ATTACHMENT 3

PROPOSED TECHNICAL SPECIFICATION

Marked-up Technical Specifications Pages,

3-26
3-27
3-47
3-48
3-49
5-03
5-04
7-30
8-08
8-21
8-22
8-23

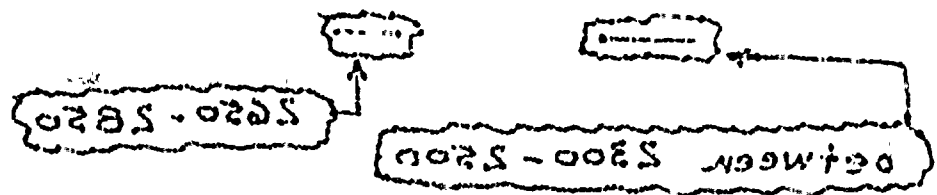
- 8) Verifying that the auto-connected loads to each diesel generator do not exceed 2500 kW (Unit 3), 2874 kW (Unit 4);
- 9) Verifying the diesel generator's capability to:

**If Specification 4.8.1.1.2.g.4)b) is not satisfactorily completed, it is not necessary to repeat the 24-hour test. Instead, the diesel generator may be operated at 2500 kW Unit 3, 2874 kW (Unit 4) for 1 hour or until operating temperature has stabilized and then within 5 minutes repeat Specification 4.8.1.1.2.g.4)b).

between 2300 - 2500

2650 - 2850
